**TO:** District of Columbia Zoning Commission  
**FROM:** Jennifer Steingasser, Deputy Director- Development Review & Historic Preservation  
**DATE:** February 28, 2014  
**SUBJECT:** Preliminary Report – ZC 13-12 – Consolidated and Preliminary PUD at 1333 M Street, SE, with Associated Map Amendment

**I. OFFICE OF PLANNING PRELIMINARY RECOMMENDATION**

**Figure 1. Consolidated and Preliminary PUD Site Plan**

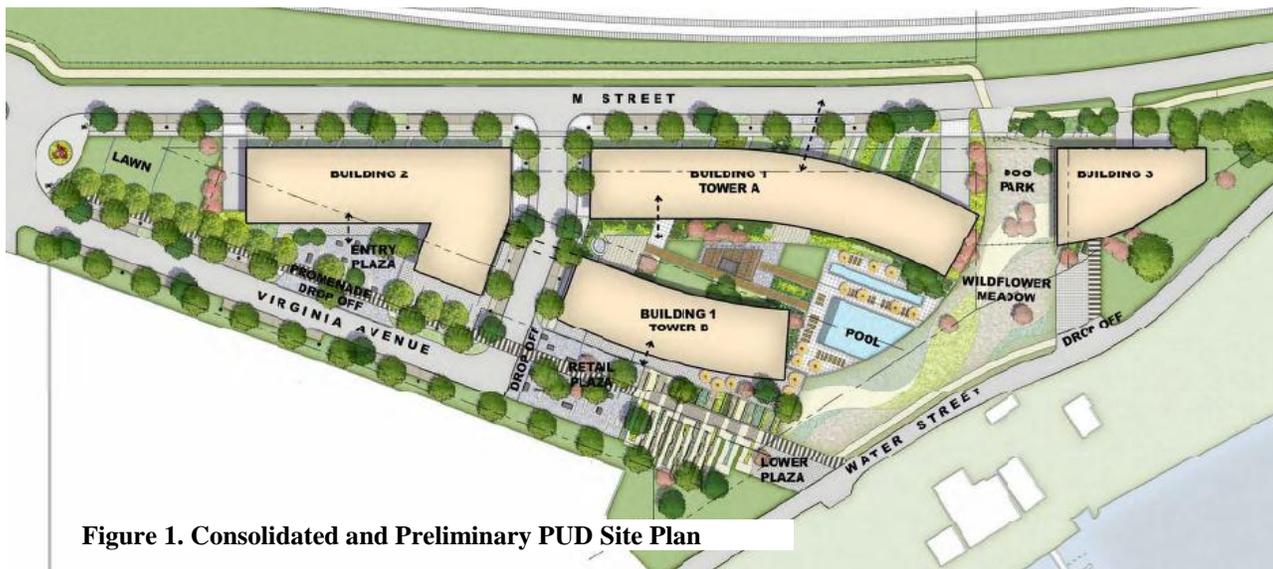
Relief would be required for varying roof structure heights, rear and side yards, open courts, loading berth lengths, locating parking for one building on a different theoretical lot, and length of consolidated PUD approval.

Figure 4. Consolidated PUD - as of 10-20-13

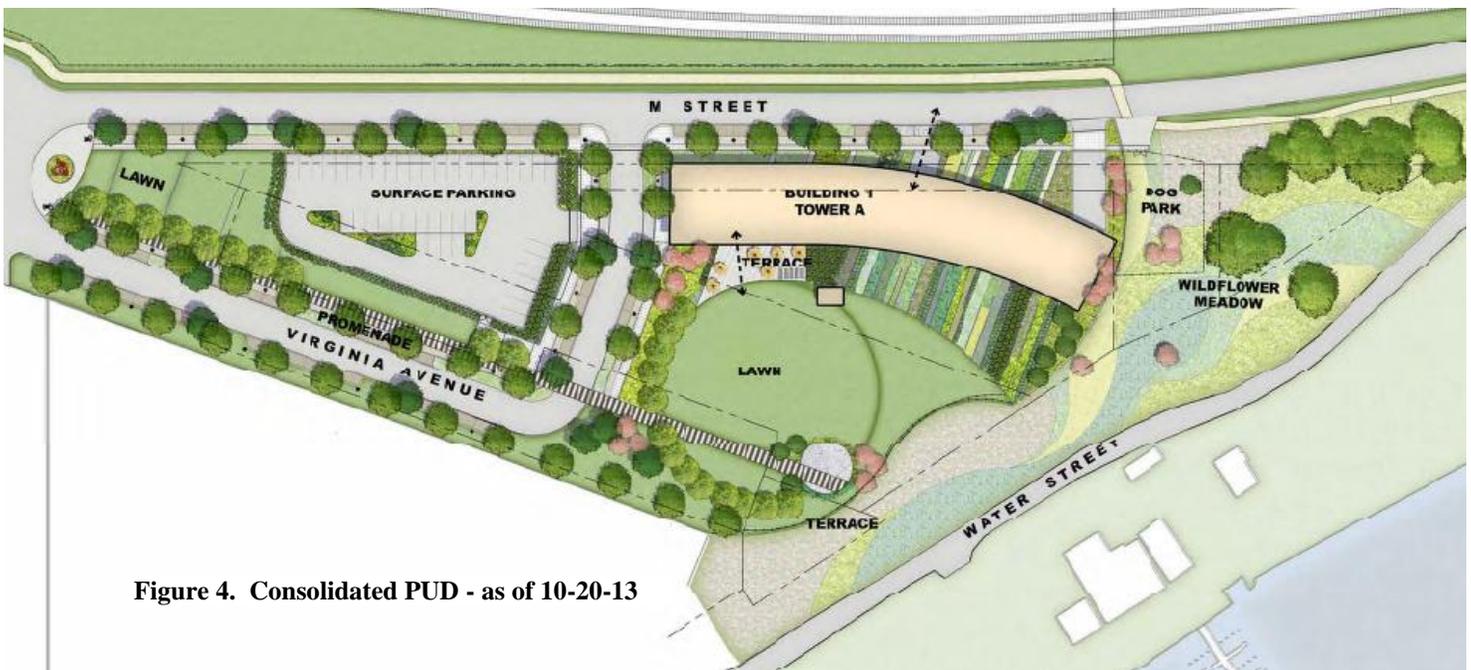
The architecture of Building 1, Tower A is bifurcated. The north side is intended to respond to both the red brick industrial buildings at the nearby Navy Yard and to traditional Capitol Hill facades with their masonry construction and punched windows. The south side is intended to connote the open feel of the waterfront it faces and capture views with extensive use of glass.

OP has encouraged the applicant to apply fresh approaches to the project’s architecture, and recommends the applicant continue to study and refine the building’s design with the following concerns in mind:

- The appropriate color and materials comprising the north façade’s High Pressure Laminate (HPL) panels
- Whether alternative façade designs could and should establish a subtler interplay of elements of the contrasting north and south facades.
